REQUEST

Current Zoning: N1-A (neighborhood 1 – A)
Proposed Zoning: UR-2(CD) (urban residential, conditional)

The petition proposes to allow a 14-unit townhome development on a vacant parcel located between Park Road and Wintercrest Lane and on the north side of Fairview Road.

PLANNING STAFF REVIEW

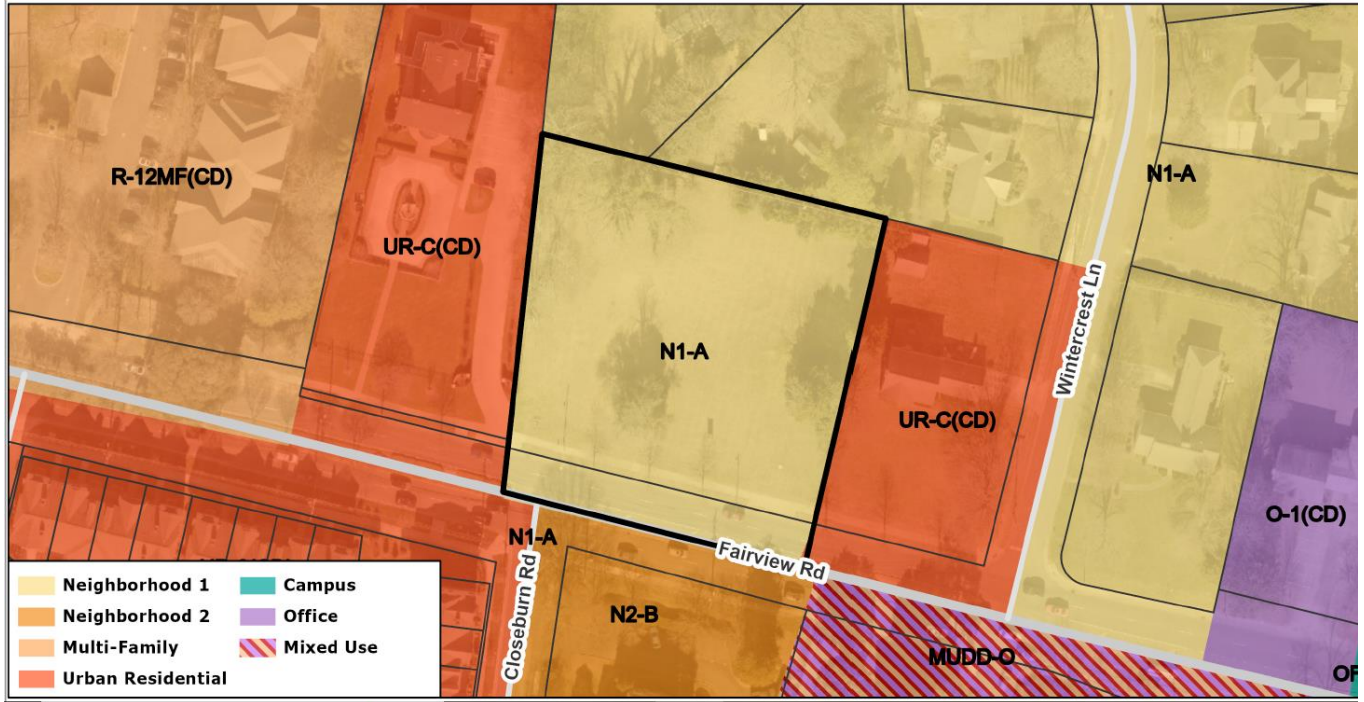
OUTSTANDING ISSUESSite and Building Design

1. Limit the building height to 45 feet.
2. Proposed eight-foot Class C buffer along east property line should be increased to 10 feet with language included it will not be reduced by 25%.

3. Amend Architectural Standards Note 4 to read "The units along Fairview Road shall provide a porch or stoop facing Fairview Road." The 400 square feet of private open space will be required by the ordinance anyway, so that language can be removed.

4. Amend language to Limit the number of dwelling units in one building to four when fronting Fairview Road.
5. The site plan shows a 15-foot sanitary sewer main line that runs parallel to a portion of the north property line. The petitioner needs to show and label the actual width of the sanitary sewer easement on the site plan. Provide a minimum 10-foot Class C buffer outside the sanitary sewer easement along the north property line. Show and label the buffer on the site plan and commit to this improvement in the development notes, specifying to not be reduced by 25%.
